CCW IMPOUNDMENTS INSPECTION REPORT

ROXBORO STEAM ELECTRIC PLANT PERSON COUNTY, NORTH CAROLINA

**PROJECT NO. 09-4157
OCTOBER, 2009**

**TRANSMITTAL
DRAFT INSPECTION REPORT
ASSESSMENT OF DAM SAFETY COAL COMBUSTION SURFACE IMPOUNDMENTS
ROXBORO STEAM ELECTRIC PLANT
PERSON COUNTY, NORTH CAROLINA**

PIEZOMETER LOCATIONS
ROXOBORO STEAM ELECTRIC PLANT
DAM SAFETY INSPECTION
PREPARED FOR

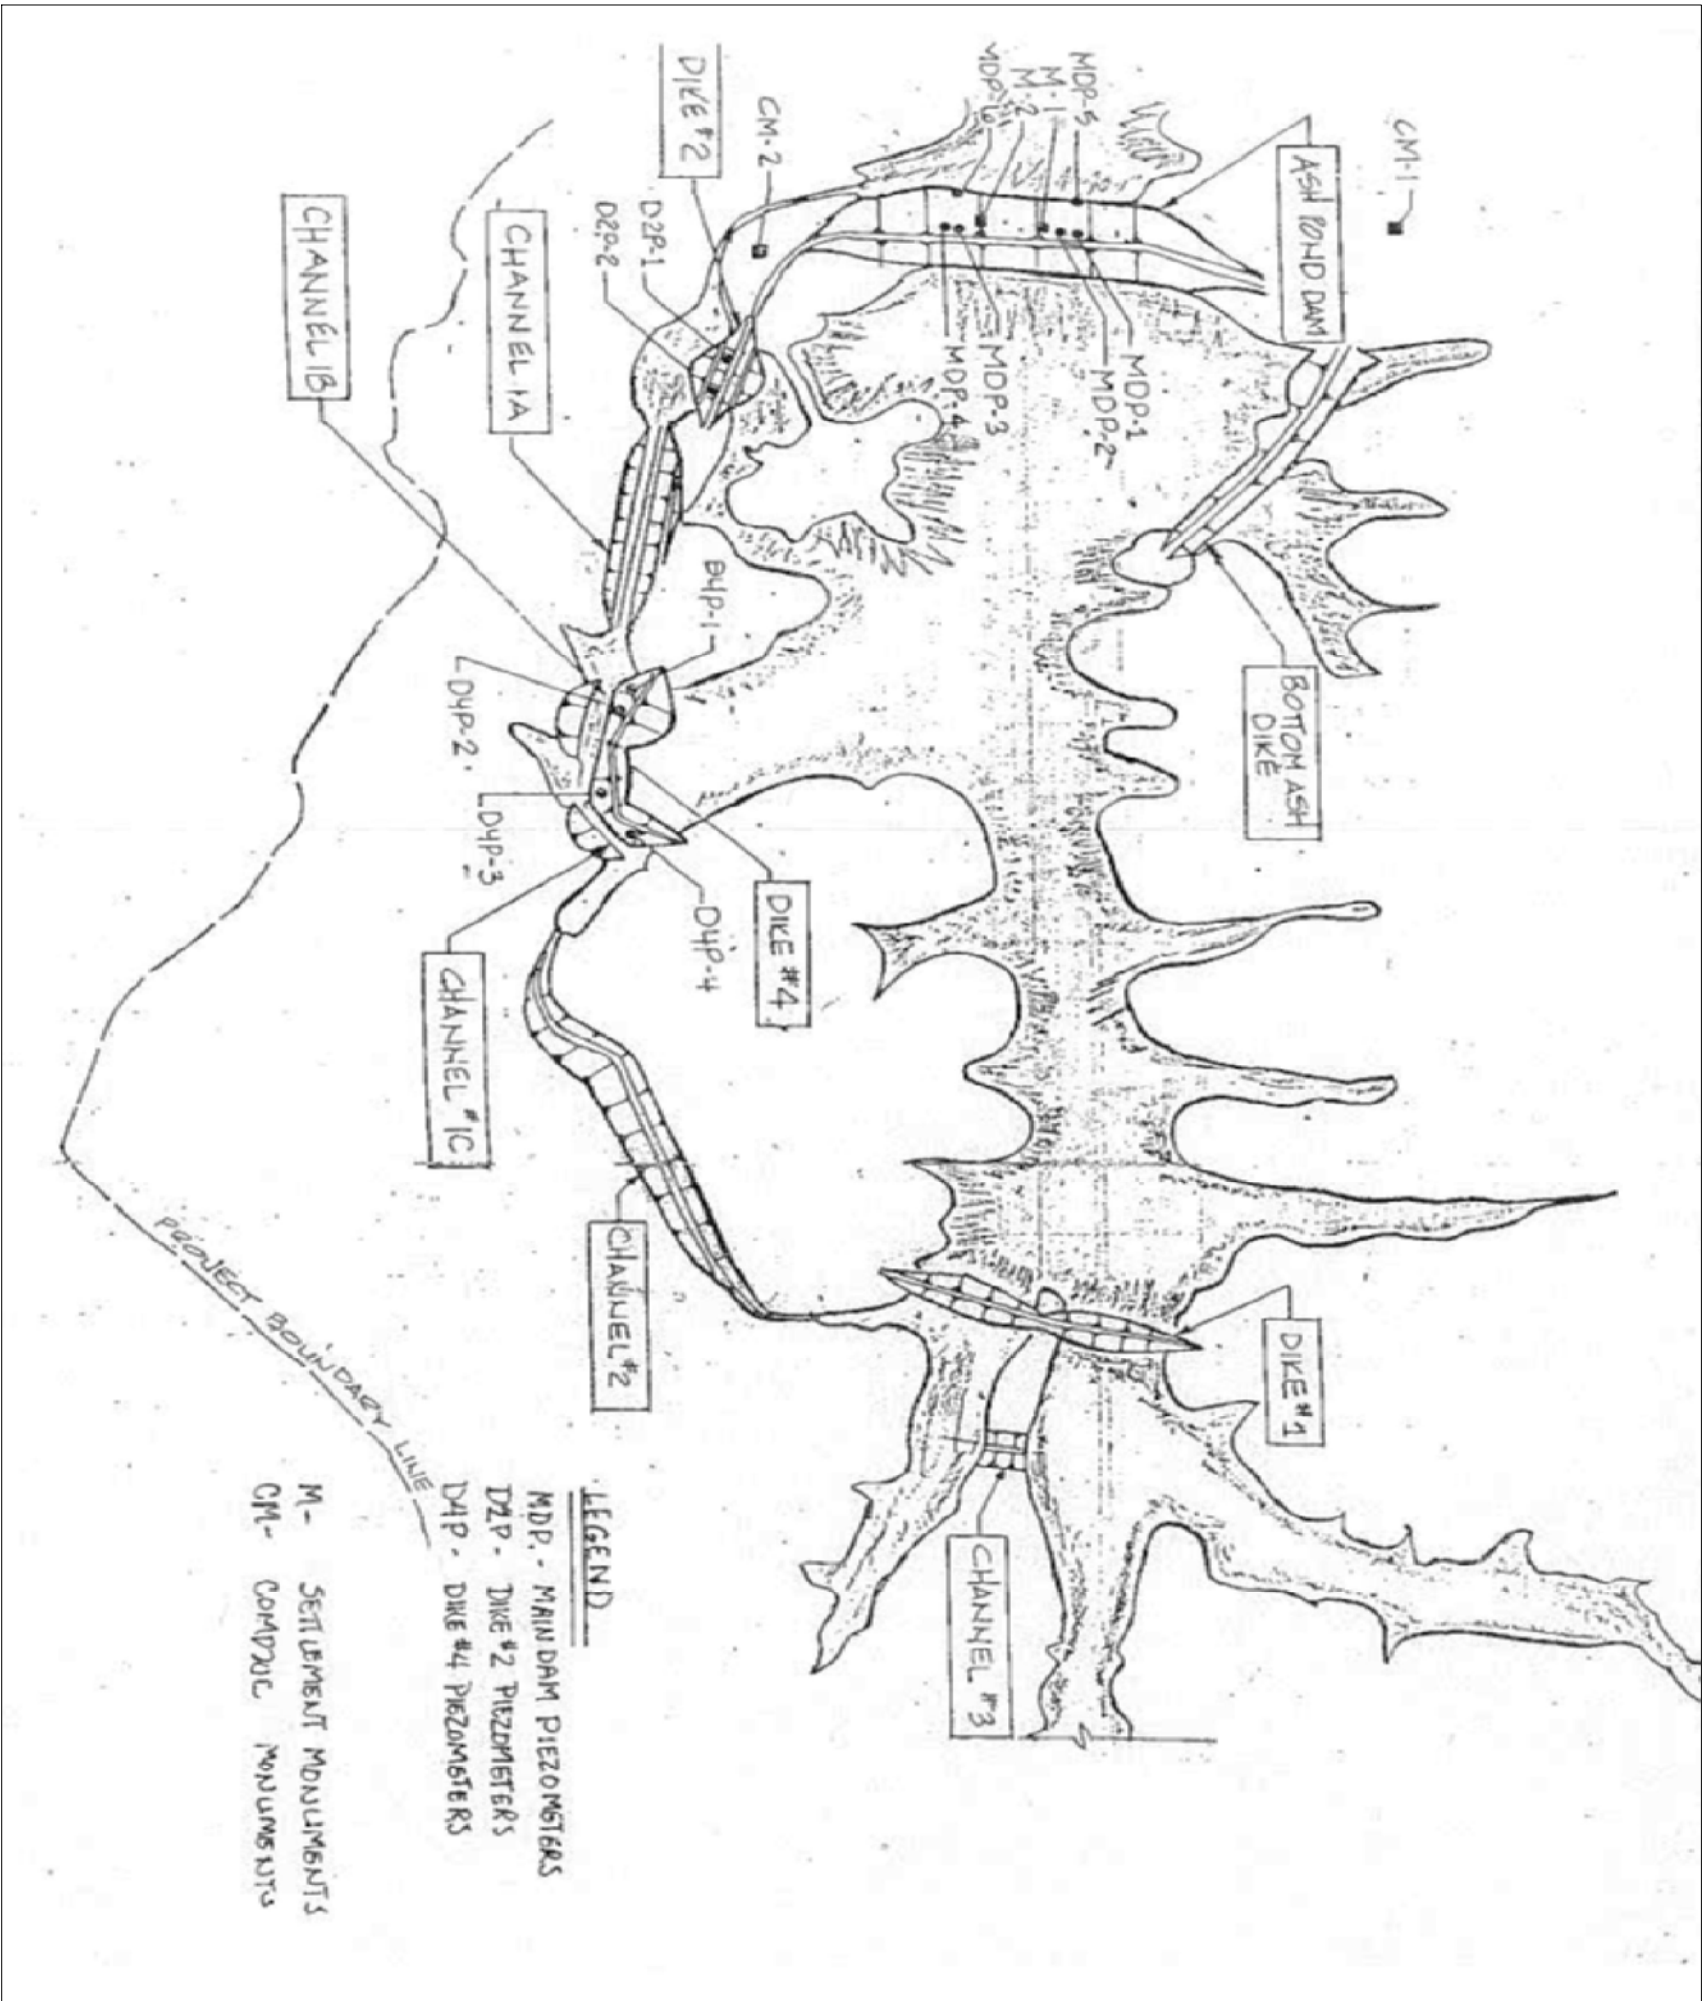
Dike No. 1 is constructed of rock excavated from channel No. 2 (Figure 4). The crest elevation is 473 feet (MSL). The design slopes are 1.3(H) to 1(V) on both upstream and downstream slopes. The dam has a 20- foot wide berm on the downstream slope below

Increase frequency of reading West Ash Pond Dam piezometers to monthly until the planned revisions to the 2006 wastewater treatment pond dike within the ash pond area have been completed.
